**CITY OF SAINT PAUL  
HERITAGE PRESERVATION COMMISSION STAFF REPORT**

FILE NAME: 445 Smith Avenue North  
DATE OF APPLICATION: August 4, 2015 (additional materials 8-11, 8-17, 8-20)  
APPLICANT: Thomas Schroeder  
OWNER: Thomas and Ann Schroeder  
DATE OF HEARING: August 27, 2015  
HPC SITE/DISTRICT: *pending* Limestone Properties Thematic Nomination (P.O.S. 1850-1899)  
CATEGORY: Contributing  
CLASSIFICATION: Building Permit  
STAFF INVESTIGATION AND REPORT: Amy Spong  
DATE: August 19, 2015

Photo 5- Rotted wood and missing/deteriorated stone materials at base of stud wall

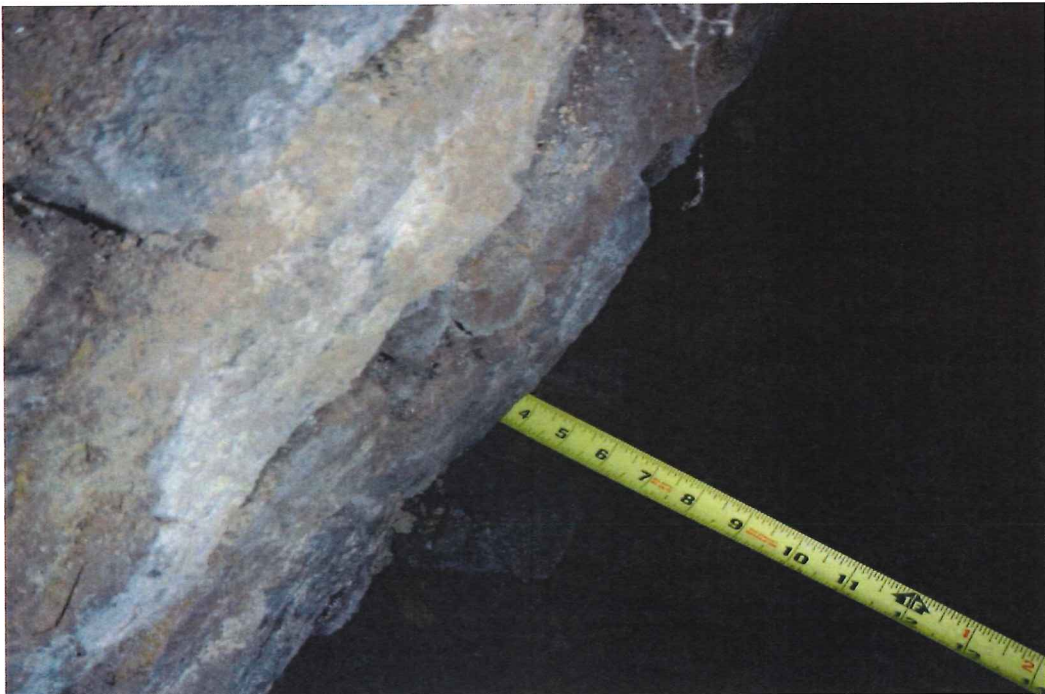
Photo 4- Rotted wood and deteriorated stone materials at base of stud wall

Photo 6- Looking downwards at a section of stone that had deteriorated along the foundation wall

Photo 7- Deteriorated joists and sill at bearing on stone foundation wall

SHEET NO. SK1

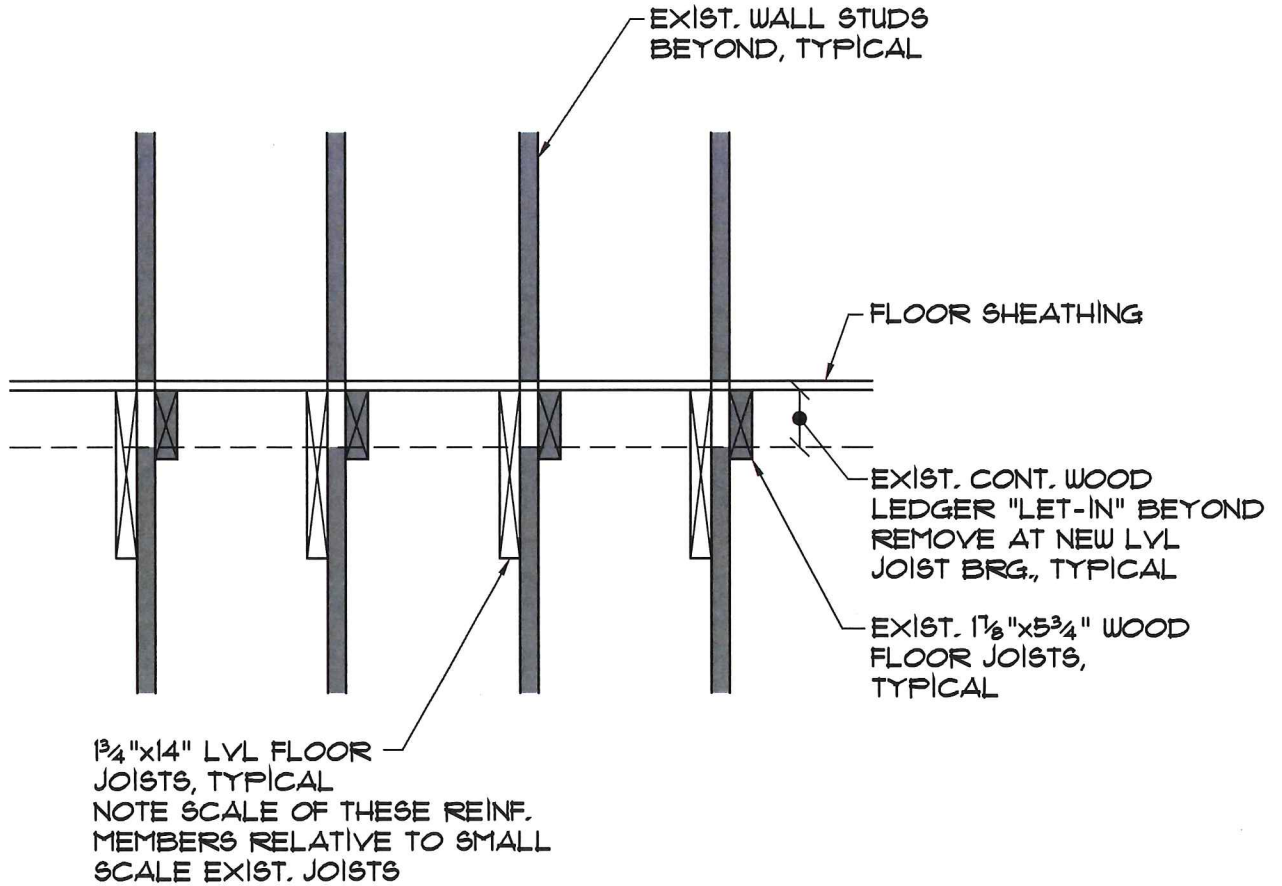
## SECTION AT SECOND
